UNITED STATES PATENT AND TRADEMARK OFFICE

APPLICATION NO.	FILING DATE	FIRST NAMED INVENTOR	ATTORNEY DOCKET NO.	CONFIRMATION NO.
10/769,164	01/30/2004	James H. Kralick	89190.109203/DP-308949	7762

DETAILED ACTION

FIG. 1

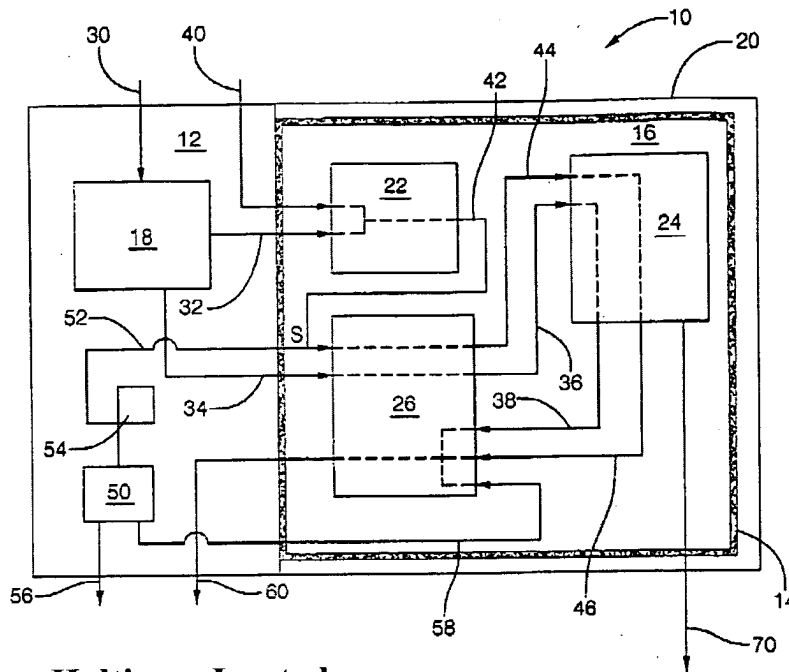
2. Claims 1-4, 9 and 12 are rejected under 35 U.S.C. § 103(a) as being unpatentable over Haltiner, Jr. et al. Haltiner, Jr. et al. disclose a system for monitoring the performance of a fuel stack for a fuel cell (see Fig. 1 below) having all of the recited elements including a fuel stack (24), a hydrocarbon reformer (22) for supplying gaseous fuel in the form of continuous reformat to the stack ; a quantitative hydrocarbon sensor (5) (being any sensor (i.e. catalytic, optical, solid oxide electrode, etc.) to measure hydrogen, methane, carbon monoxide, carbon dioxide, water etc. Haltiner, Jr. et al. col. 5, lines 40-55) (as recited in claims 3 and 4) for measuring hydrocarbon content (as recited in claims 1 and 12) wherein the means for providing a sample of reformat output are an equivalent to the means disclosed in the instant specification.

FIG.1 Walz et al.

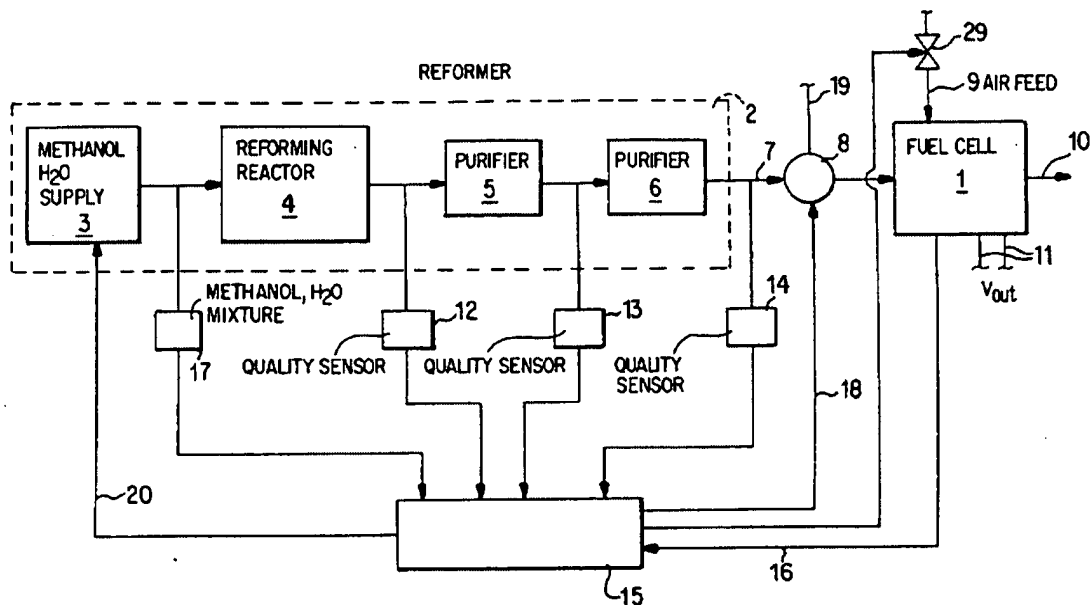
3. Claims 5 and 10 are rejected under 35 U.S.C. § 103(a) as being unpatentable over Haltiner, Jr. et al. as applied to claim 1 above, and further in view of Walz et al. Haltiner, Jr. et al. disclose a fuel cell and system for monitoring the performance of a hydrocarbon reformer having all of the elements stated previously. However, Haltiner, Jr. et al. do not expressly disclose means for providing air to the sensor nor means for shutting down the fuel cell. Walz et al. disclose a method of monitoring the performance of a fuel stack having most of the recited elements of independent claims 1 and 12 (see Fig. 1 below) having sensors (12, 13, 14) for monitoring the quality of the reformat leaving the reformer (4) before entering the fuel stack/cell (1) wherein air/oxygen is fed on a cathode side of one of the sensors (Walz et al.: col. 3, lines 1-7); and wherein a controller can interrupt the system if the reformat quality is below a standard or switched off/shut-down completely (Walz et al.: col. 2, lines 20-25) (as recited in claim 10). It would have been obvious to one having ordinary skill in the art at the time the

invention was made to feed air/oxygen to a sensor monitoring the reformat for the purposes of having the sensor simultaneously monitoring the air supply or oxygen supply to the fuel cell arrangement (Walz et al.: col. 3, lines 5-7), as well as shutting down the system of delivering reformat to the fuel cell/stack to prevent damage.
